# ADDENDUM NO. 1

Perry Township Schools Phase 2:  
Perry Meridian High School Central Plant and Southport High School Electrical Infrastructure  
SPHS: 971 E. Banta Road  
Indianapolis, IN 46227  
PMHS:401 W. Meridian School Rd.  
Indianapolis, IN 46217

**ADDENDUM NO. ONE**

**PROJECT:** Southport High School – Electrical Improvement Package

**ELECTRICAL TEMPORARY ONE-LINE DIAGRAM**

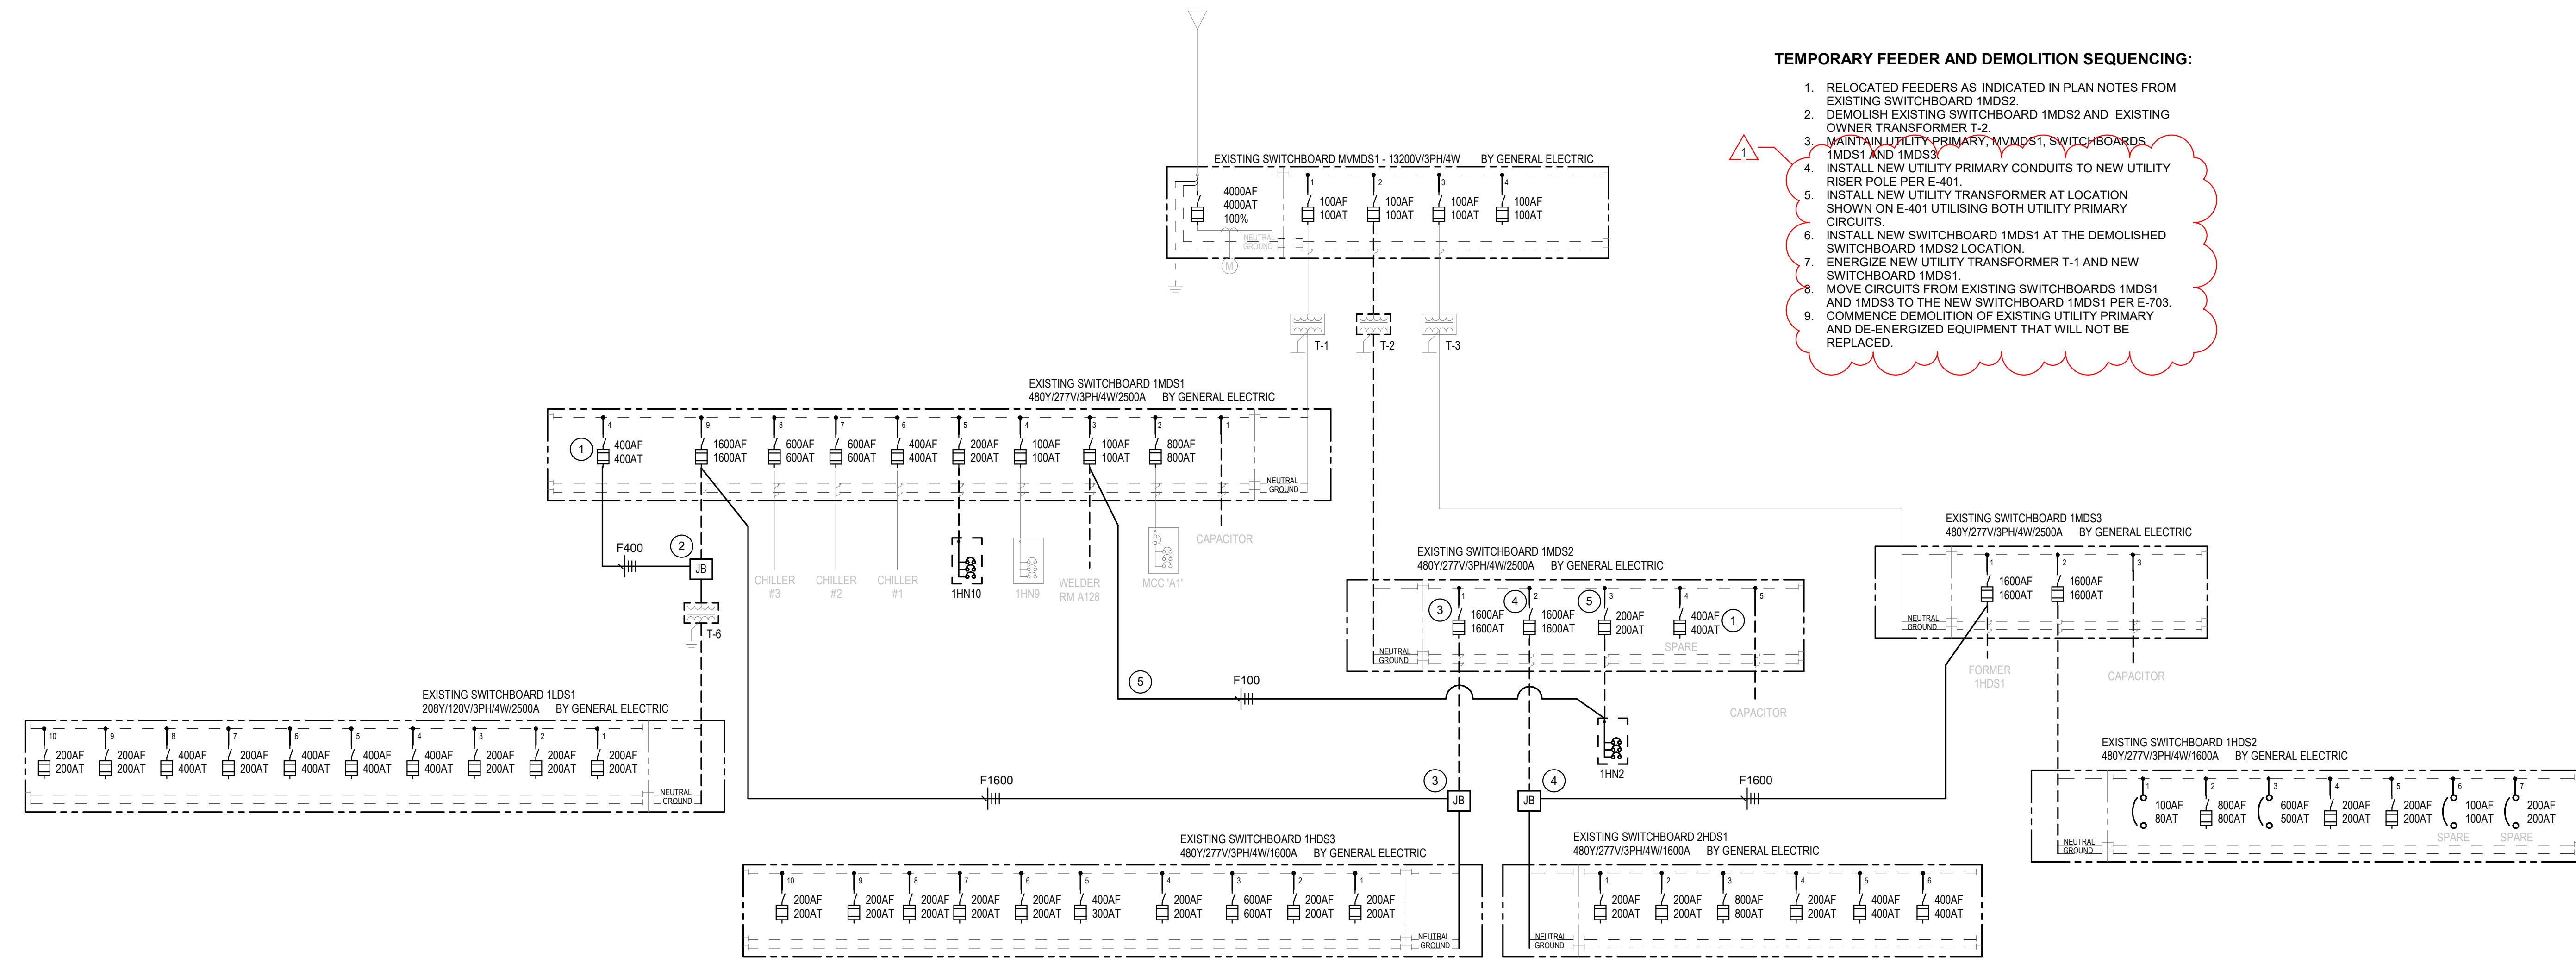
Change: Updated sequencing to coordinate with utility changes.

**ELECTRICAL ONE-LINE DIAGRAM**

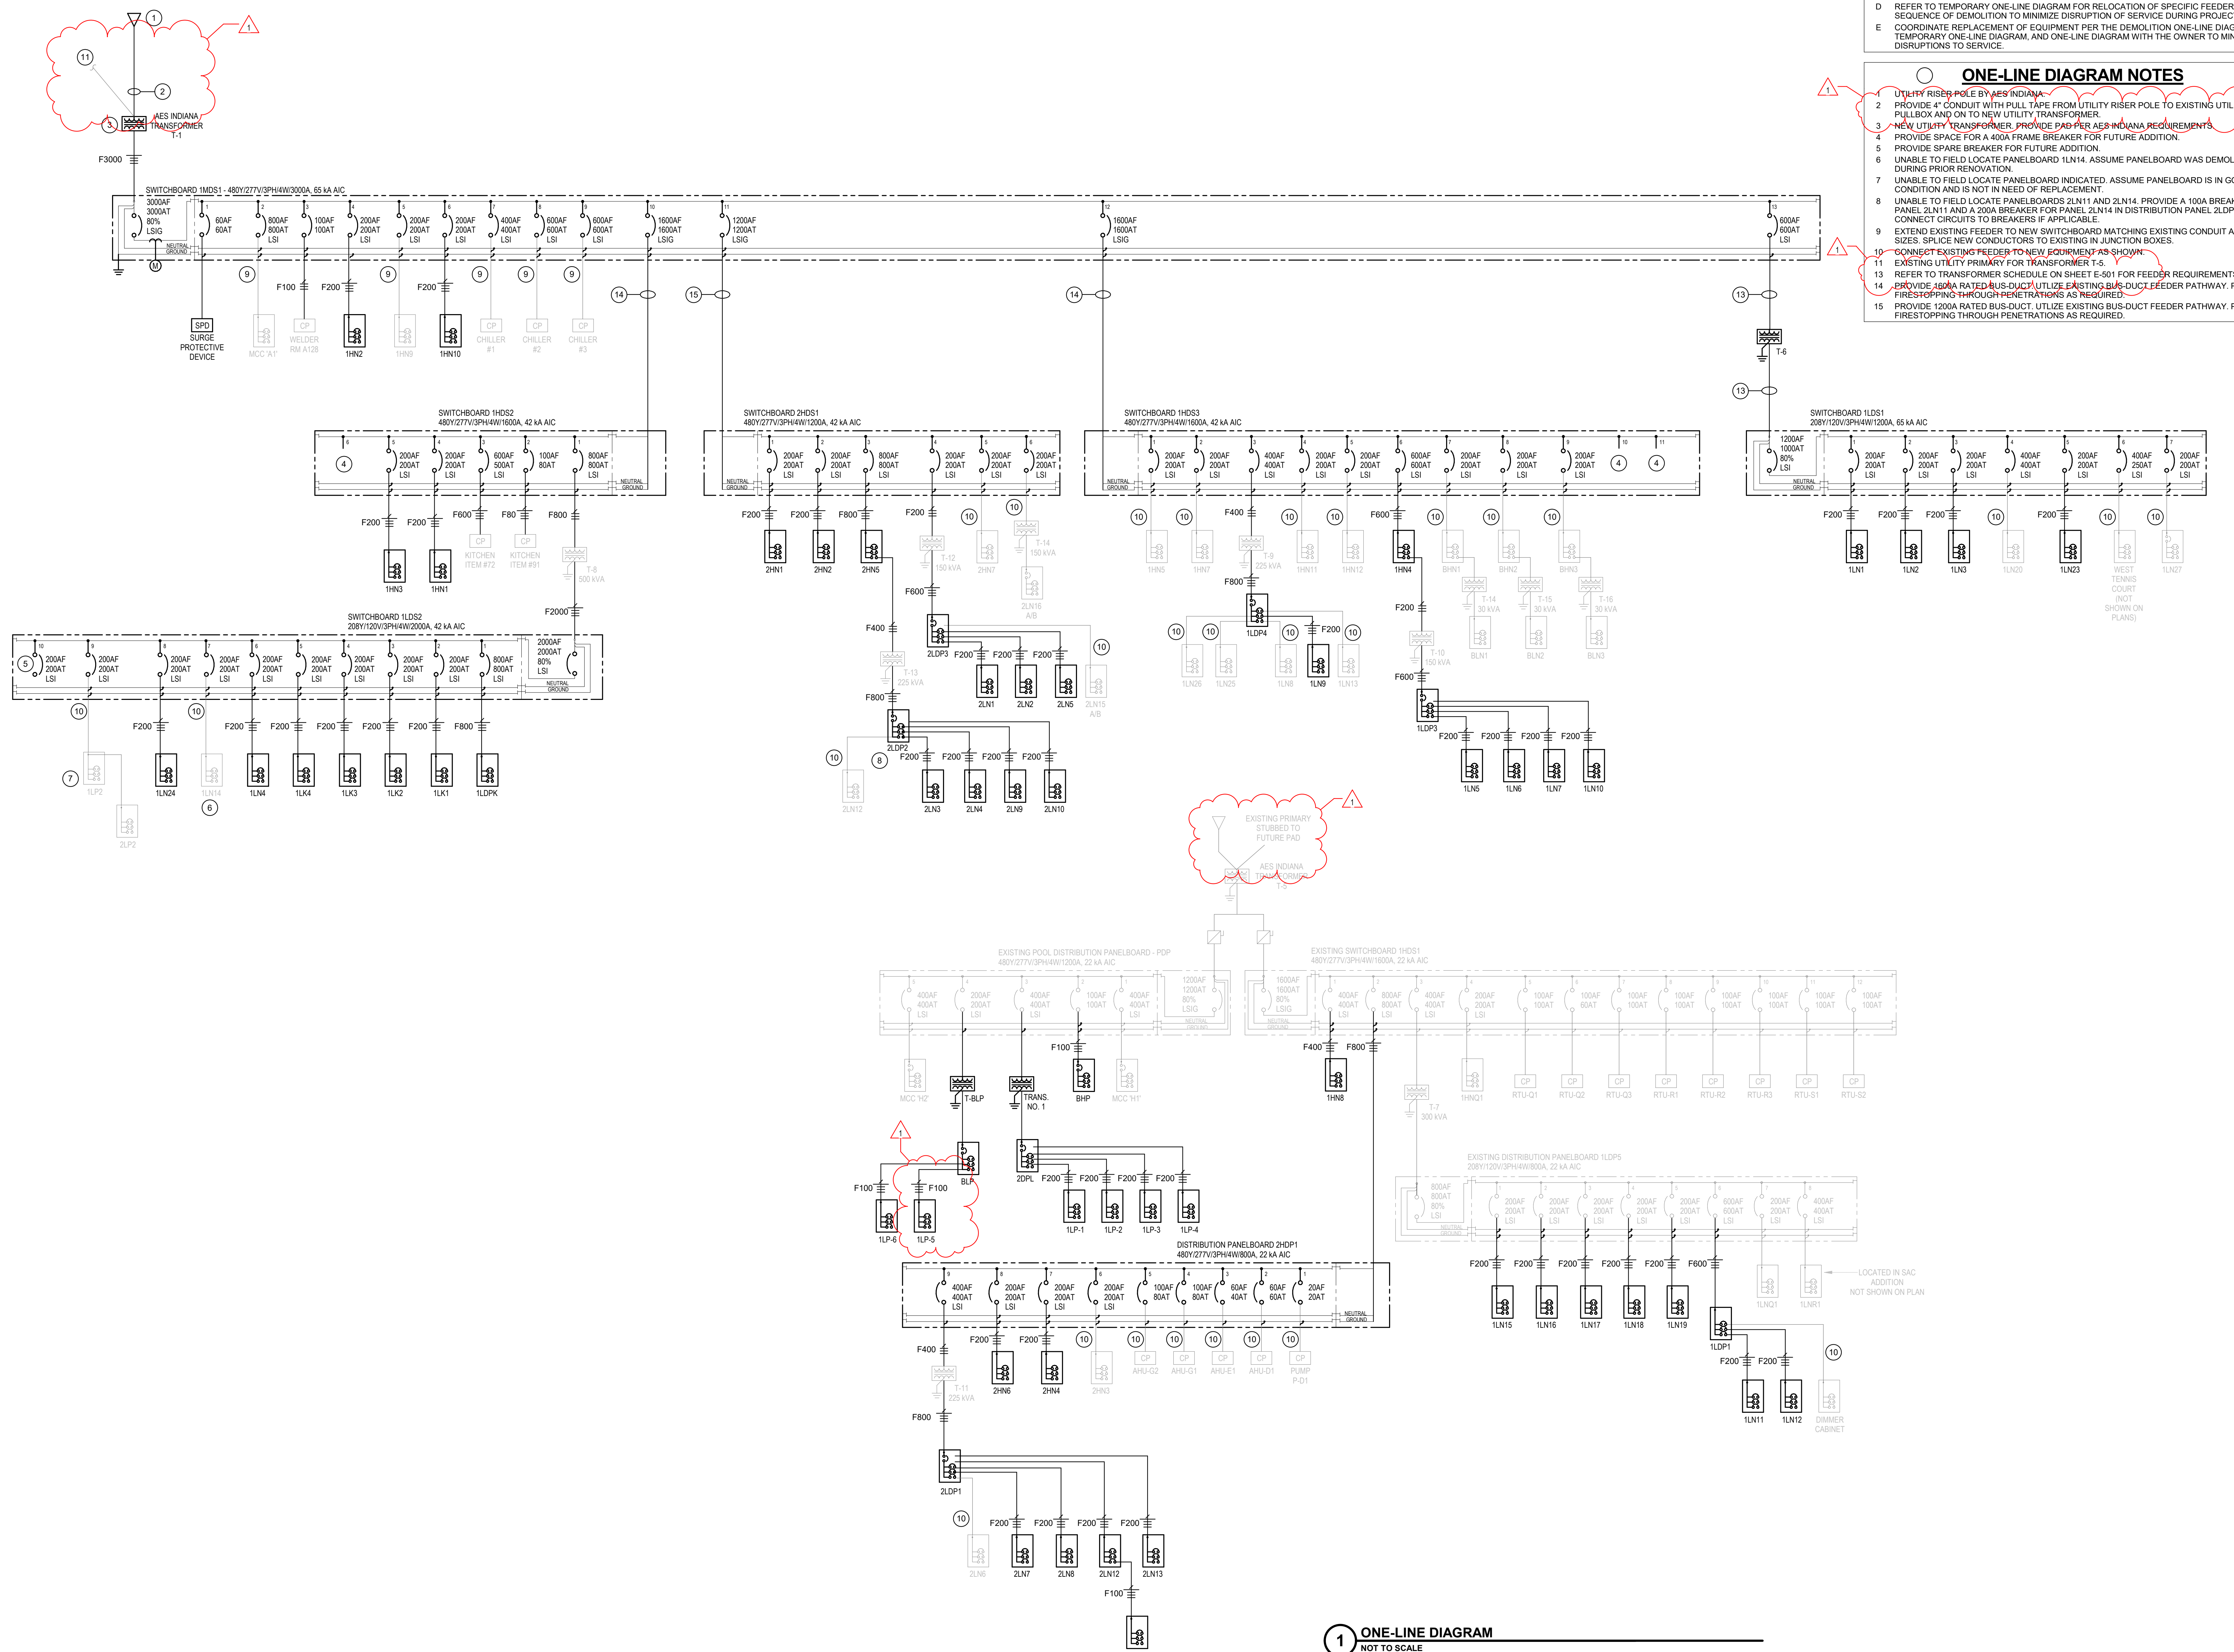
Change: Added new feeder and new panel for panelboard 1LP-5.  
Change: Updated utility primary and transformer installation design per coordination with AES Indiana.
